SHINGLEMILL

ROCKLAND ZBA & TOWN DEPT. COMMENTS - RESPONSE

Date: 12/8/20

C-102

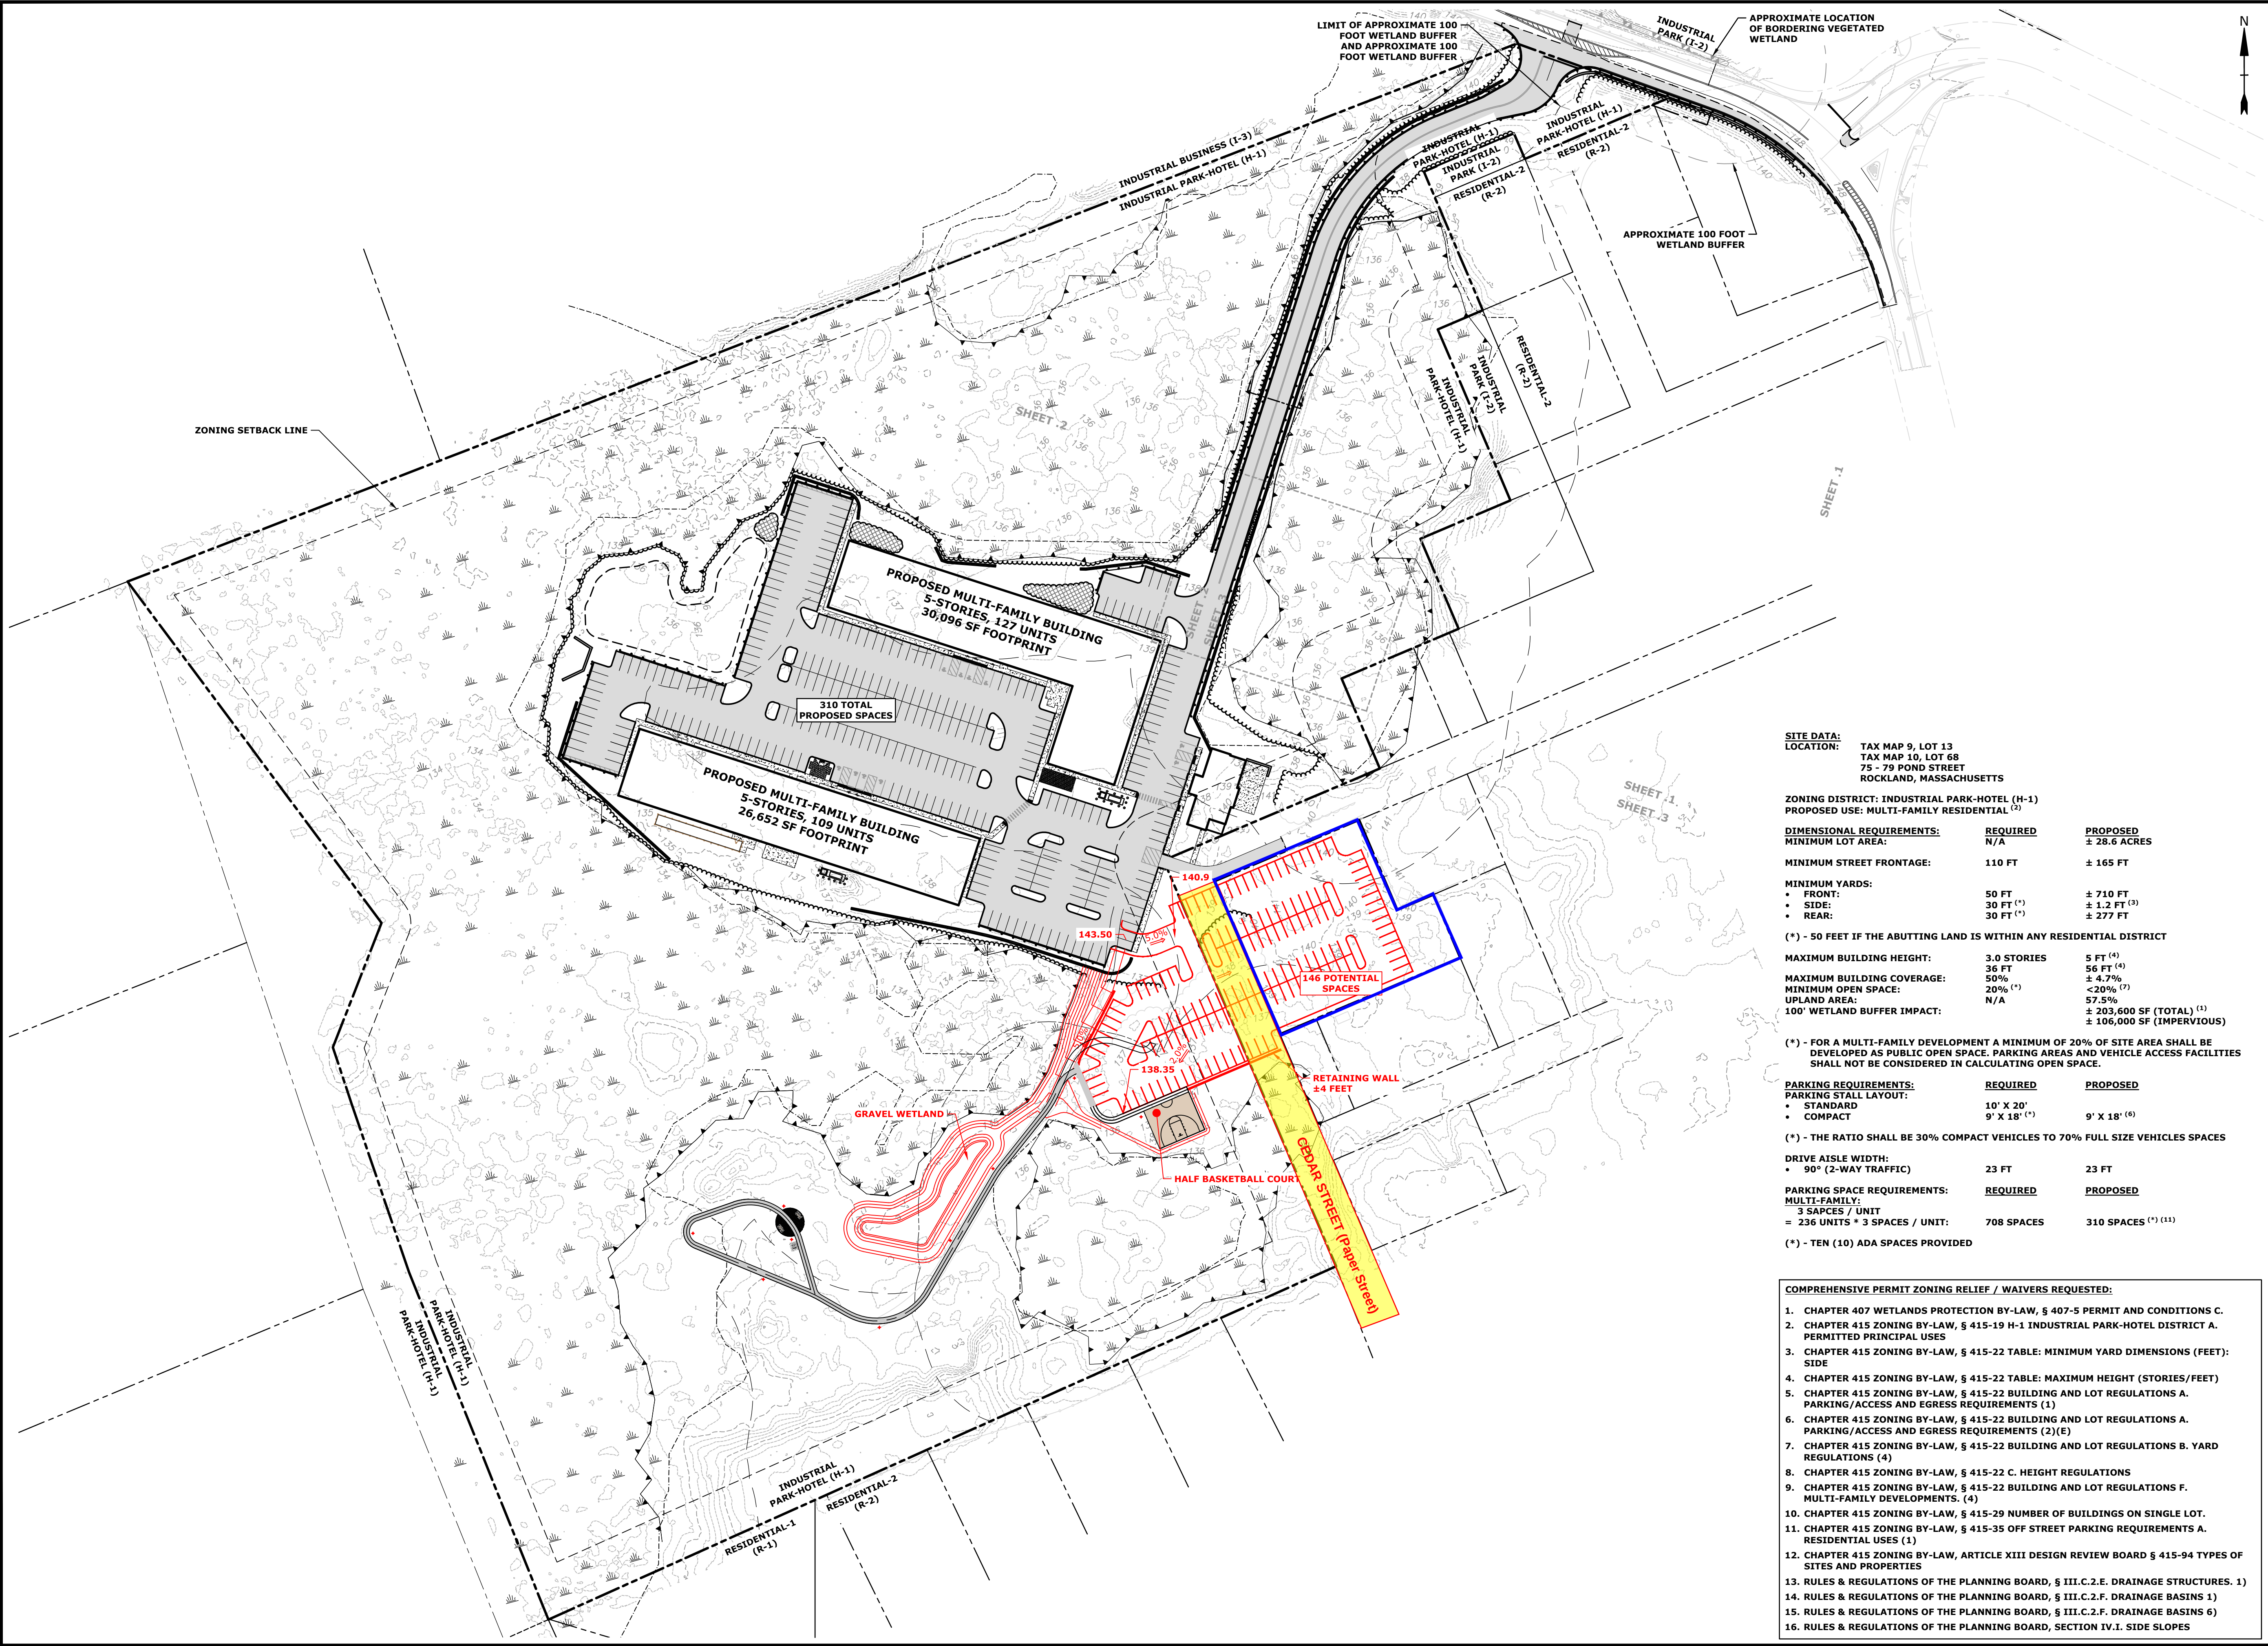
10. Some semblance of compliance with the current local wetland bylaw

Response: The applicant has made all efforts to minimize the impact on the surrounding wetlands per the town's wetlands protection by-law. Where were we not able to accomplish this, we are requesting waivers per the "Comprehensive Permit Zoning Relief/Waivers requested" section on sheet C-102 of the 12/8/20 Shinglemill Site Plan REV.
